Access Compliance Report

Public Rights-of-Way

(Curb Ramps)

Intersection ID: 8727	Main Street: NEWLAND_RD	Cross Street: SAMUEL_ST	Location: S
ADA ID: BEEB7AA29851	Ramp Type: Perp	Initial Pass/Fail: Fail	Overall Compliance: No
Severity Score: 12.5			
Codes/Mitigation Info/Possible Solution		Field Measurements/Component Compliance

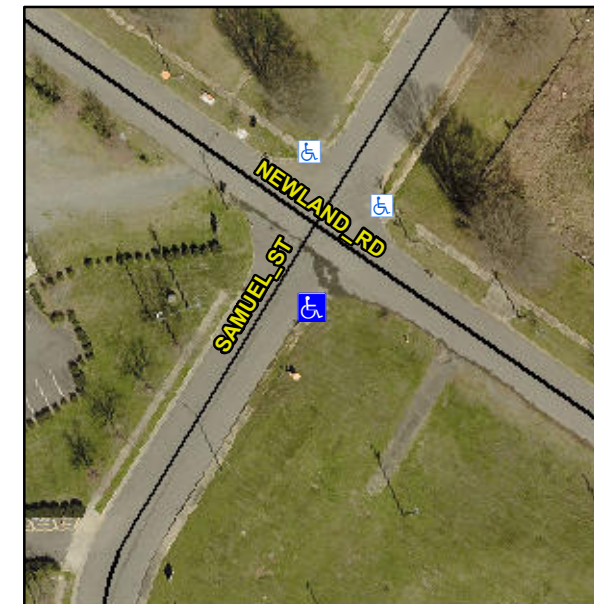
Not Found, R304.2.2

Compliance	Description	Data	Compliance	Description	Data
N/A	Ramp Length (in)	60.0	No	Ramp Slope (%)	9.9
Yes	Ramp Width (in)	48.0	Yes	Ramp XSlope (%)	0.4
N/A	Flare Type LT	N/A	N/A	Flare Type RT	N/A
N/A	Flare Slope LT (%)	N/A	N/A	Flare Slope RT (%)	N/A
N/A	Flare Traversable LT?	N/A	N/A	Flare Traversable RT?	N/A
N/A	Landing Length (in)	N/A	N/A	DWS Provided?	N/A
N/A	Landing Width (in)	N/A	N/A	DWS Contrast?	N/A
N/A	Landing Slope (%)	N/A	N/A	DWS Length (in)	N/A
N/A	Landing X Slope (%)	N/A	N/A	DWS Full Width?	N/A
N/A	Landing Curb? (Y/N)	N/A	N/A	DWS Offset (in)	N/A
N/A	Shared Landing?	N/A			
N/A	Gutter Ponding?	N/A	N/A	Gutter Slope (%)	N/A
N/A	Gutter Lip Ht (in)	N/A	N/A	Gutter X Slope (%)	N/A
N/A	Painted X Walk1?	No	N/A	Painted X Walk2?	N/A
	X Walk 1 Direction	To NE		X Walk 2 Direction	N/A
N/A	X Walk 1 Width (in)	N/A	N/A	X Walk 2 Width (in)	N/A
	X Walk 1 Slope (%)	1.6		X Walk 2 Slope (%)	N/A
	X Walk 1 X Slope (%)	0.4		X Walk 2 X Slope (%)	N/A

Remove & Replace Entire Ramp.
